## Appendix A.1 NOP Responses Received and Scoping Meeting Sign In

**Subject: Notice of Preparation for an Environment Impact Report for Harvard-Westlake  
Parking Improvement Plan Project, City of Los Angeles, Los Angeles County**

**Harvard-Westlake Parking Improvement Plan  
Notice of Preparation Comments  
ENV-2013-1950-EAF**

**Subject: HARVARD-WESTLAKE PARKING IMPROVEMENT PLAN PROJECT  
(REVISED) ENV 2013-0150-EIR**

SECOND LEVEL FLOOR PLAN

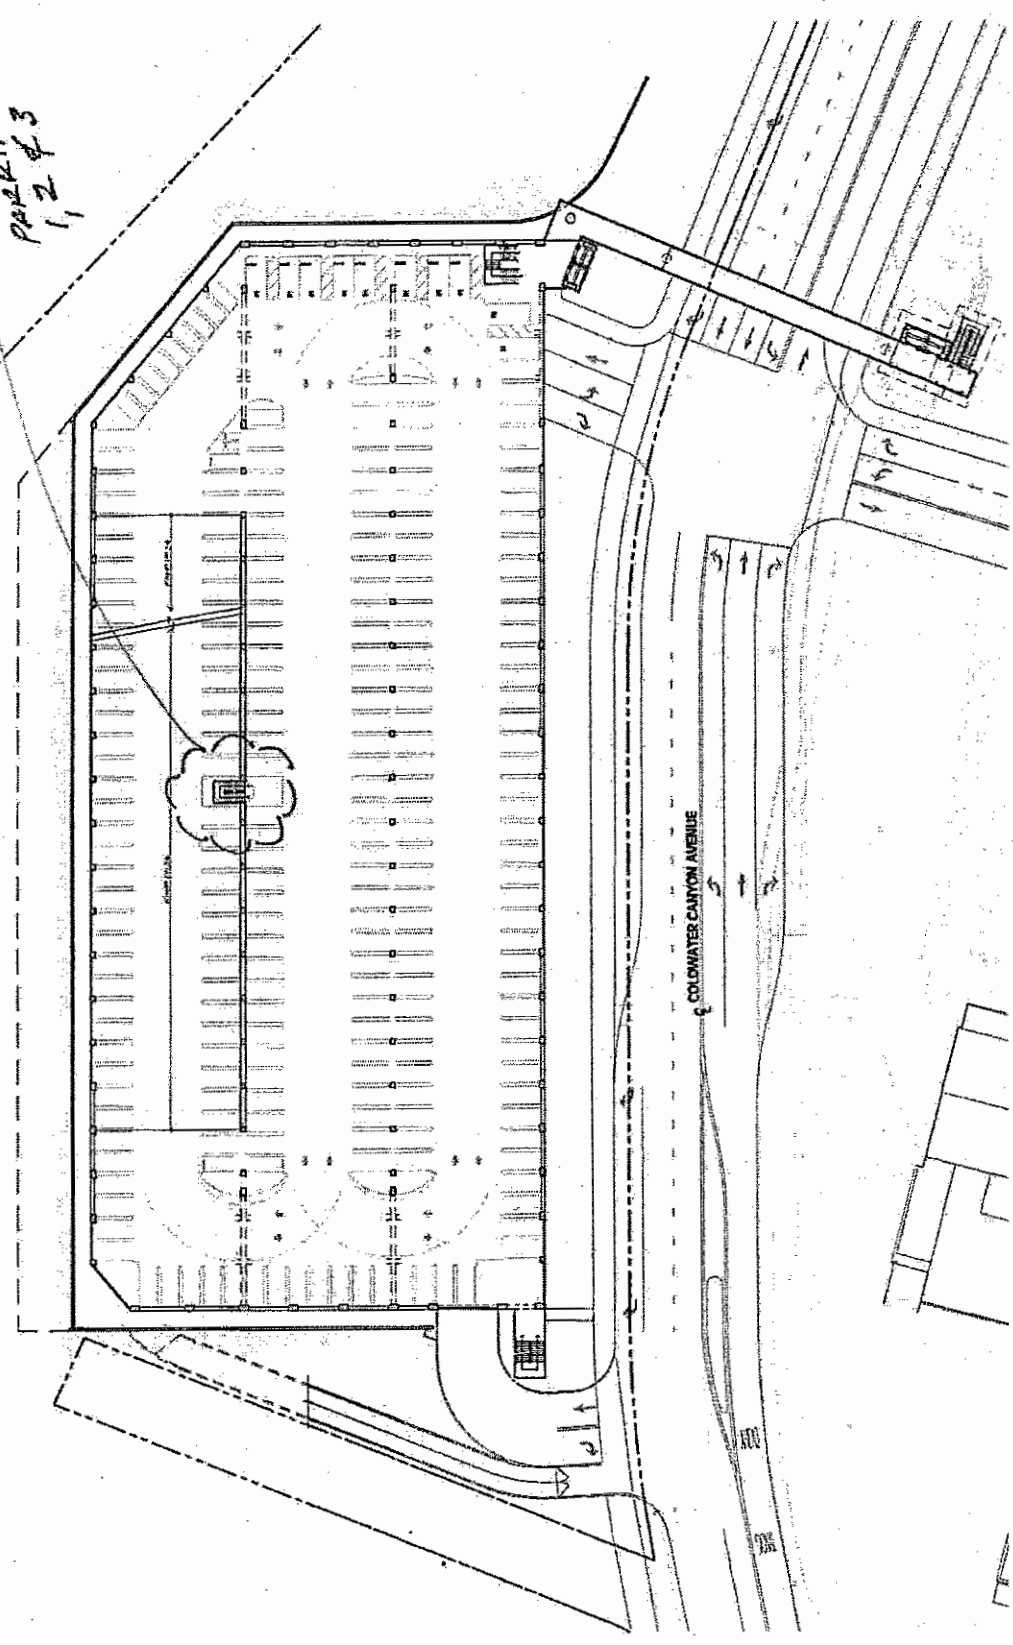
It wasn't clear to me that you were talking about an enclosed stair, however, we will provide that. We want to maintain the other two perimeter stairs open. From your view, is that acceptable?

The structure is a three level S-2 open parking structure with and modified A-3 playing field on top, open to the sky. The structure will be Type I non-combustible construction and will be fully fire sprinklered. Open stairways are provided at the North and South ends, servicing all levels. A minimum 5 ft. wide airway is provided on three sides around the structure at grade, between the building perimeter and hillside retaining wall.

In addition, Fire Department access to the structure is provided along the entire East side from Coldwater Canyon Ave., to openings on all parking levels for the full length. The roof level playing field's perimeter is surrounded by a ball catchment net, but is accessible for the entire length and is open to the sky. As discussed, we will add an additional open stairway inside the structure servicing the parking levels, with additional fire standpipe at that location (see attached drawing exhibit).

ADDED STAIR & ESC.  
 PARKING LEVELS  
 1, 2 & 3
